**Re: DA-2356-00 West Centertech – Site Plan
Comment Response Letter #4**

SITE PLAN WEST CENTERTECH

PORTION OF LOT 3, BLOCK 1, AURORA CENTRETECH PARK SUBDIVISION
(FILING NO. 8), CITY OF AURORA, COUNTY OF ARAPAHOE,
STATE OF COLORADO (APPROX. 2.34 ACRES)

SITE PLAN

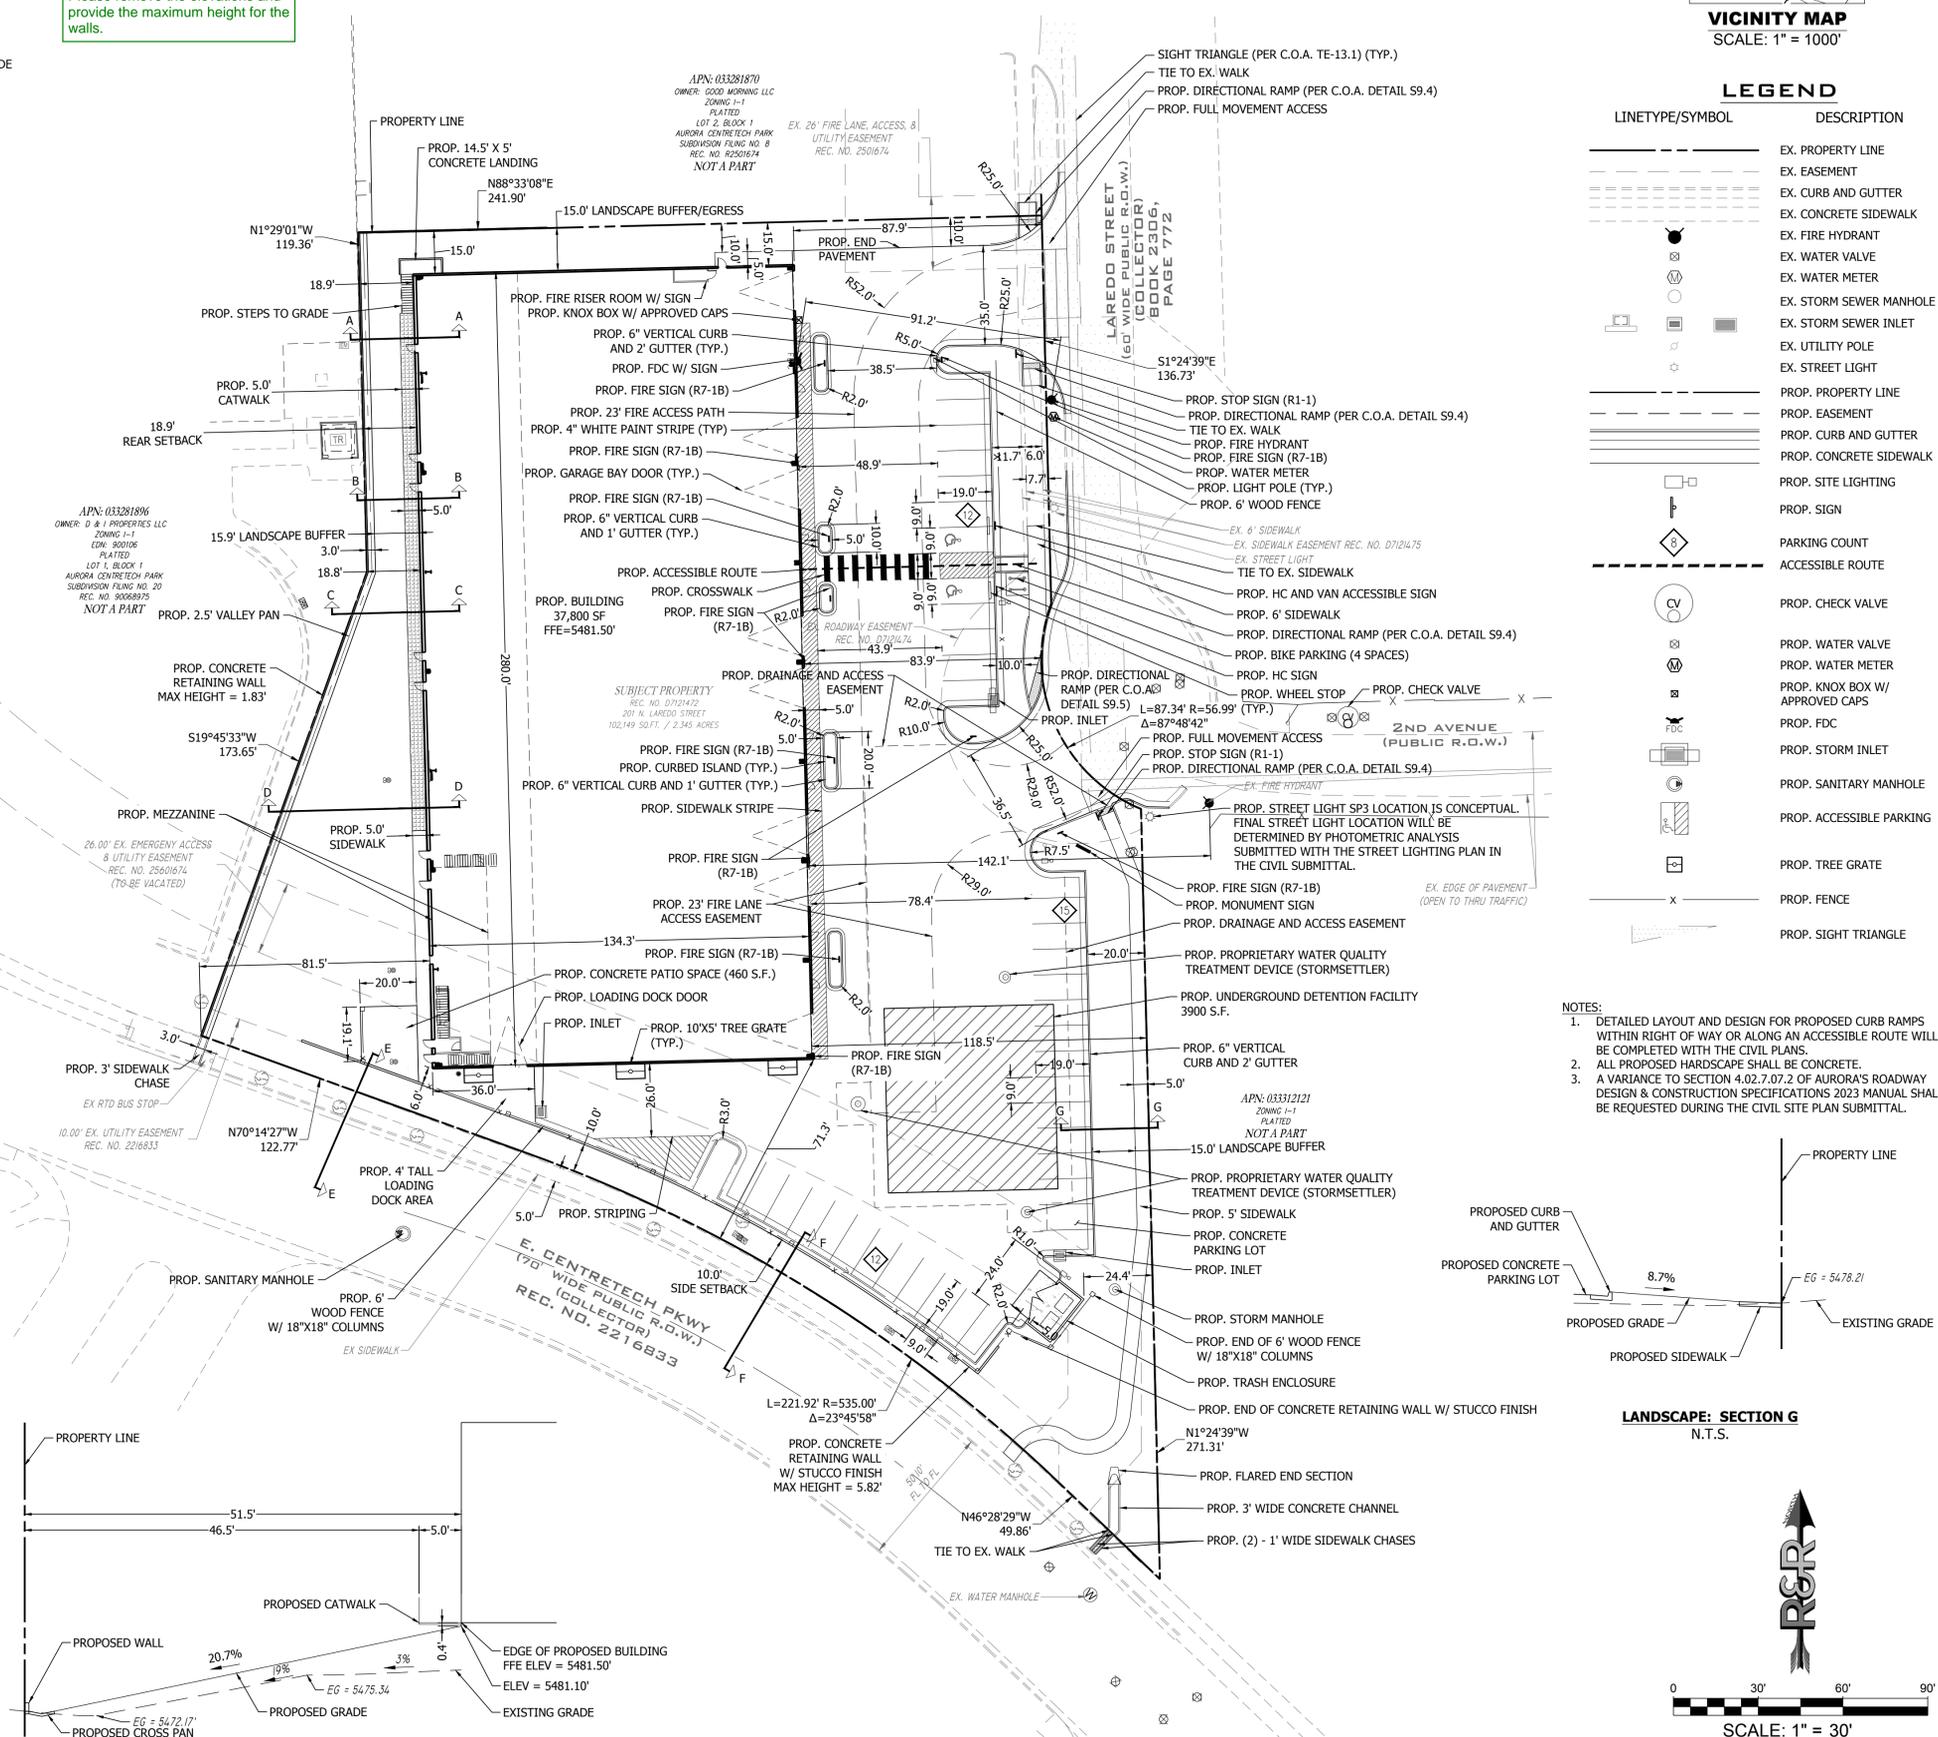
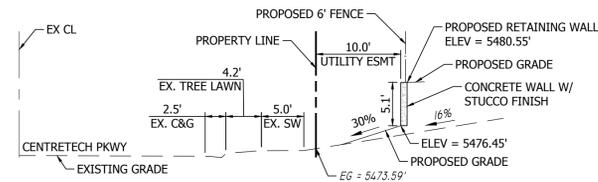
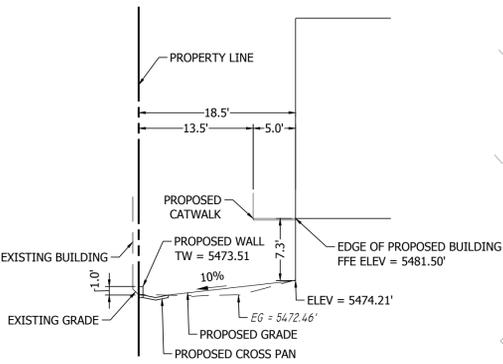
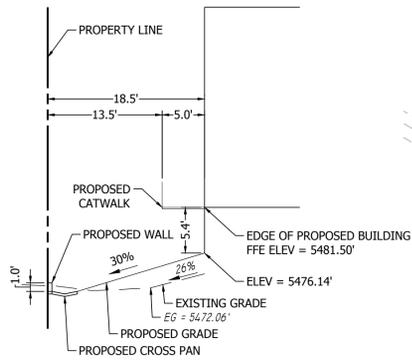
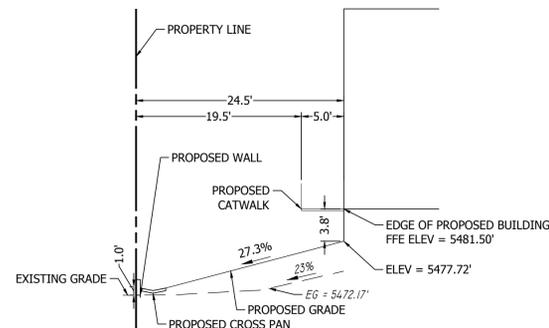
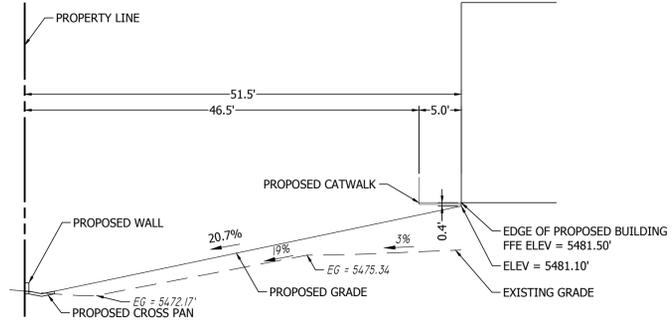
10A. Please remove the elevations and provide the maximum height for the walls.

Please remove the elevations and
provide the maximum height for the
walls.

R&R Response: Elevations removed and maximum heights added.

**RESPONSE: WALL ELEVATIONS
REMOVED AND MAX HEIGHTS ADDED.**

LANDSCAPE PLAN

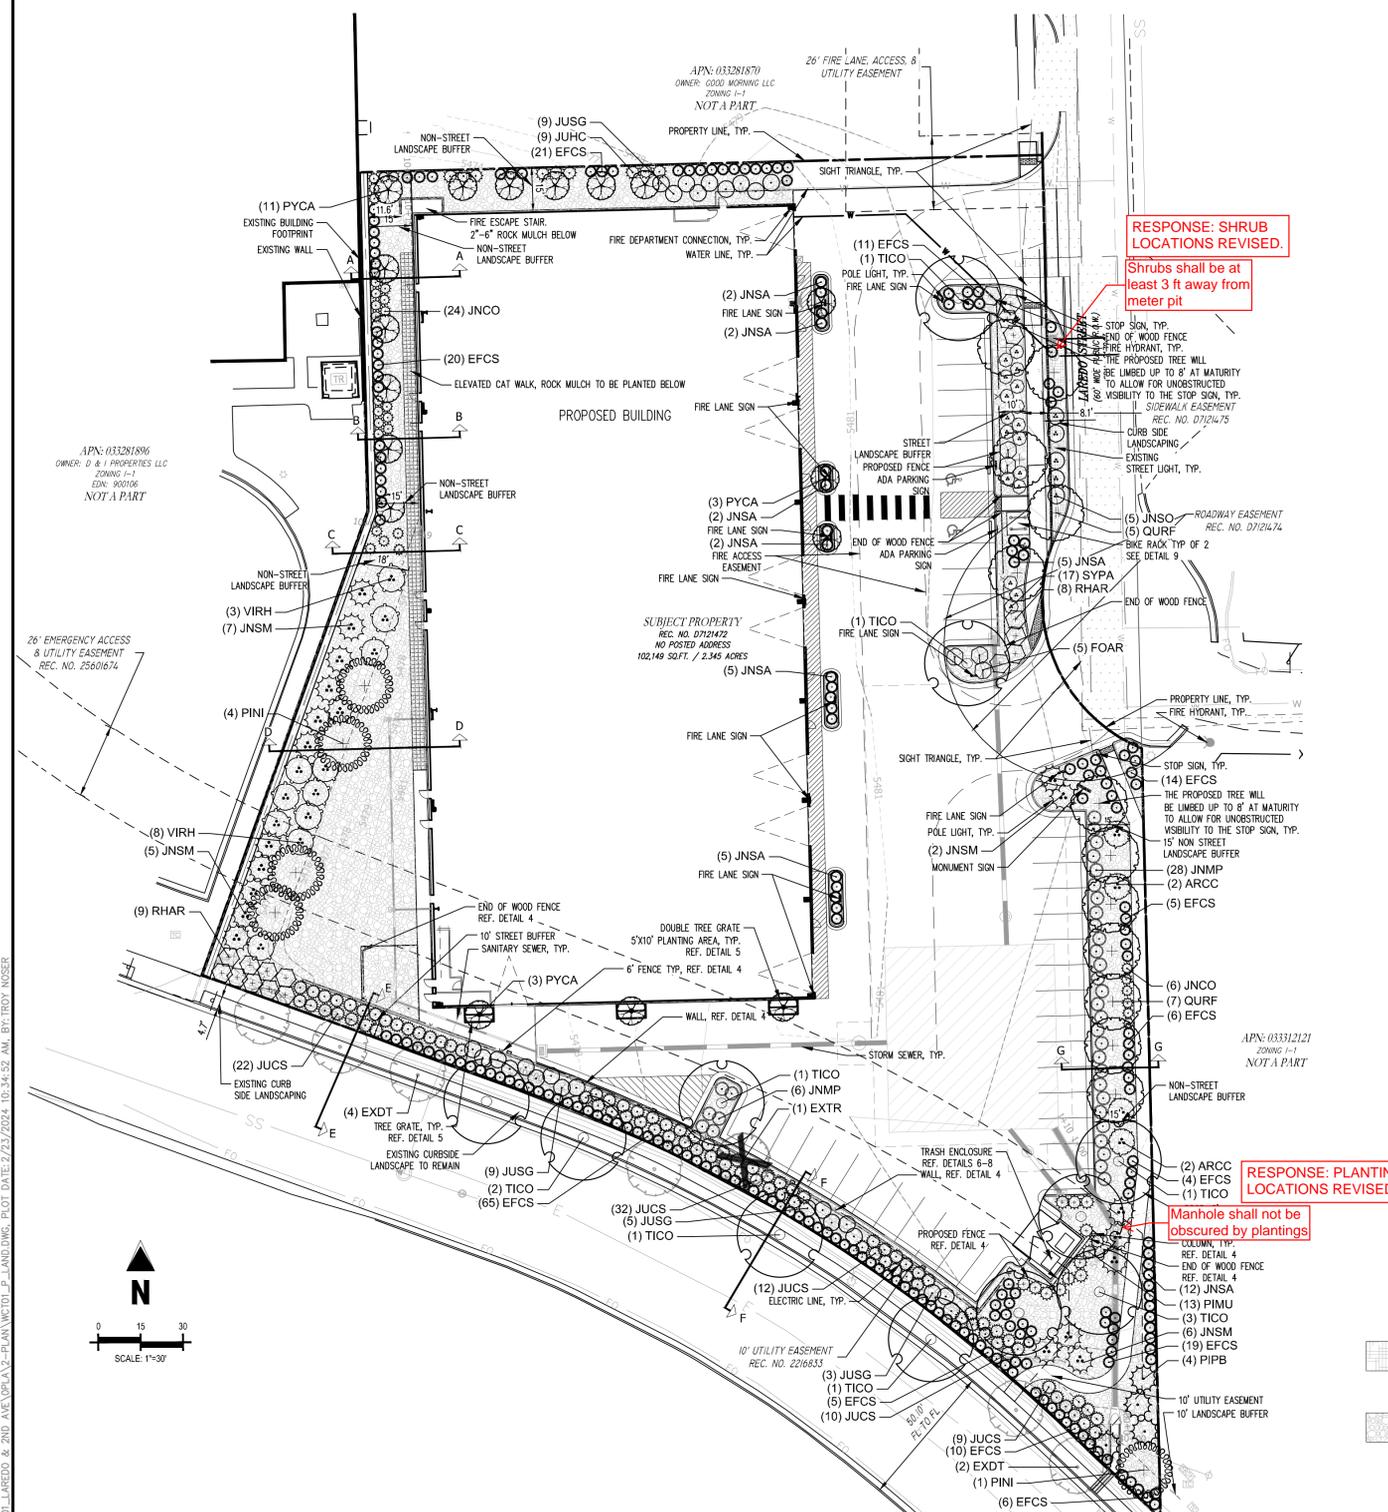
13A. Shrubs shall be at least three-feet away from the meter pit.

13B. Manhole shall not be obscured by plantings.

R&R Response: Shrub locations revised.

R&R Response: Planting locations revised.
